Business Unit: HARTING Electric

PCN/22/005/C+N-US
Product Range: Han HC Modular

Date: 03/07/2022

Title: Change TC250 and TC350

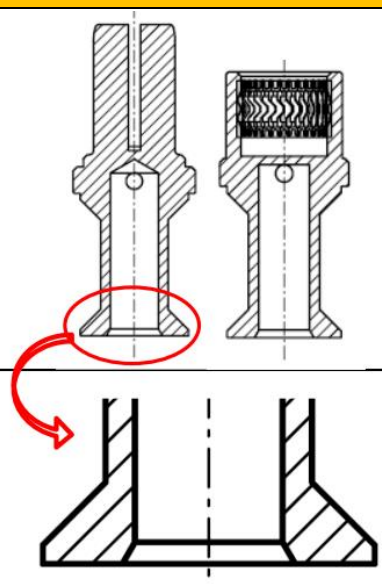
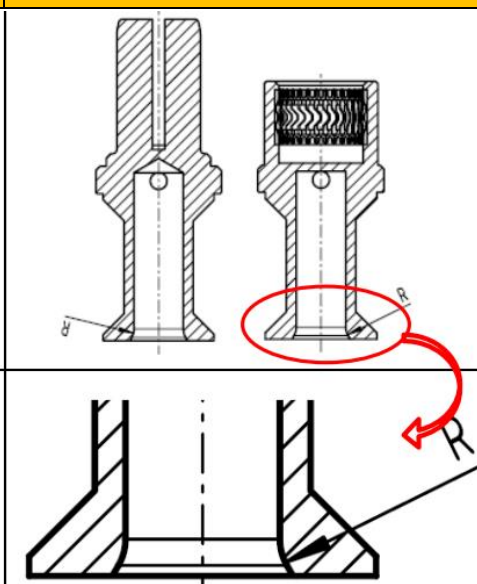
1. Concerned Part Numbers		
See appendix		
2. Description of Changes/News		
Old Design	New Design	Description
		<p>Implementation of a radius to the end of the inlet funnel of the crimp hole.</p>
3. Impact on Product Specification		
The technical characteristics according to the datasheet and the quality characteristics are not affected.		
4. Scheduled Date of Implementation		
This change will take place as of October 3 rd , 2022.		
5. Identification of Change		
New revision level
